ADDENDUM NO. 1

2021 GULF BROOK CHANNEL RESTORATION PROJECT PHASE 3

TOWN OF KEENE – ESSEX COUNTY, NEW YORK

February 4, 2021

1 EROSION AND SEDIMENT CONTROL PLAN (STATION 40+00 TO 45+00)
C1-1 N.T.S.

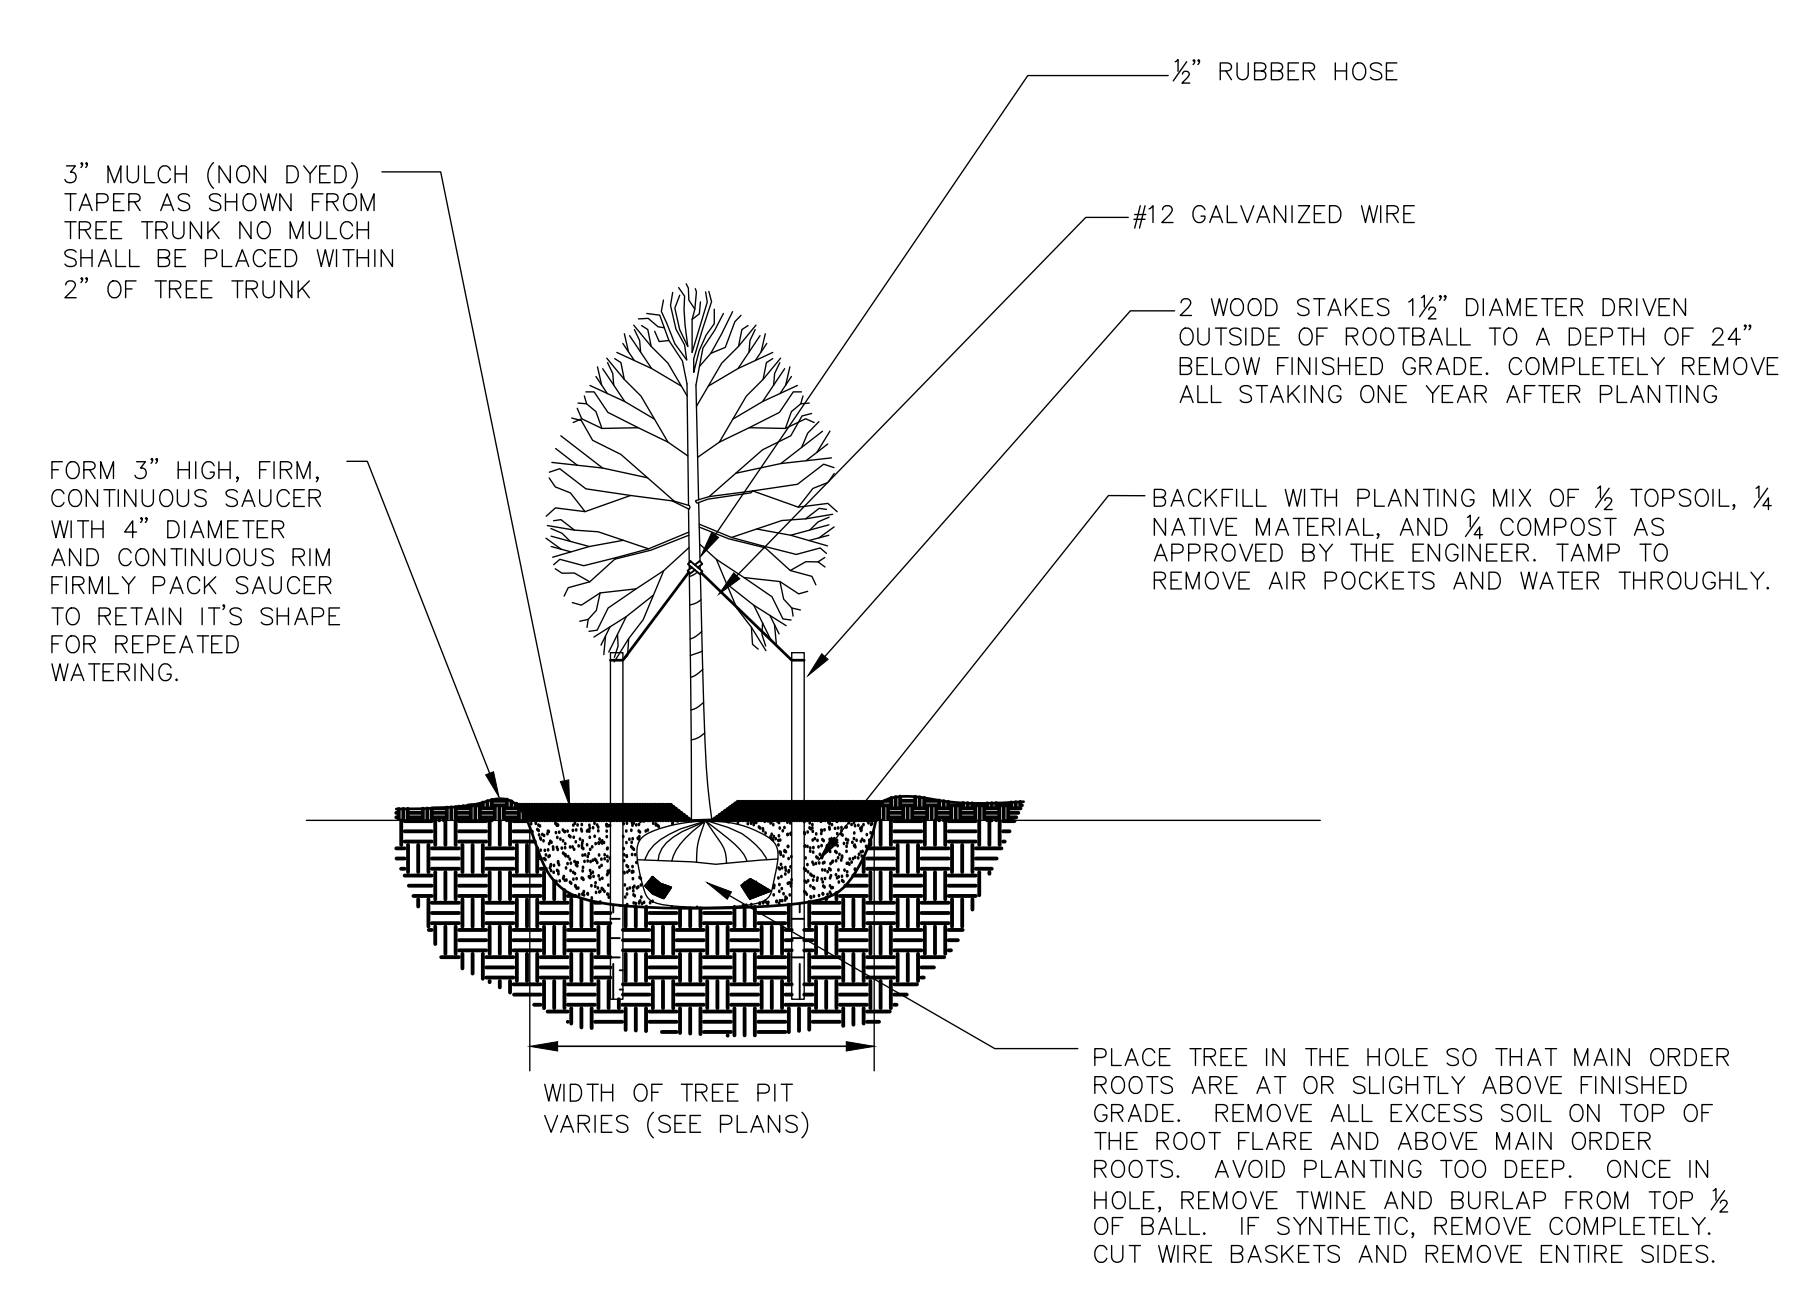
1. **General:** A Pre-Bid meeting was held for the project at the Keene Town Offices on February 3, 2021 at 10:00 AM. Minutes from the meeting are enclosed and are a part of this Addendum and the Contract Documents.
2. **Question from Prospective Bidder: Is the area between the chute and the stream to remain vegetated?** Yes.
3. **Question from Potential Bidder: What should the surface of the channel be?**
The flood chute channel surface shall be channel bed material consisting of stone and gravel. Topsoil, seed and mulch will not be applied in this area. No planting or mulching in this area.
4. **General:** Drawing sheets C1-1 and C1-3 have been revised and are attached. The call-outs for tree removals and protection have been adjusted for clarity.
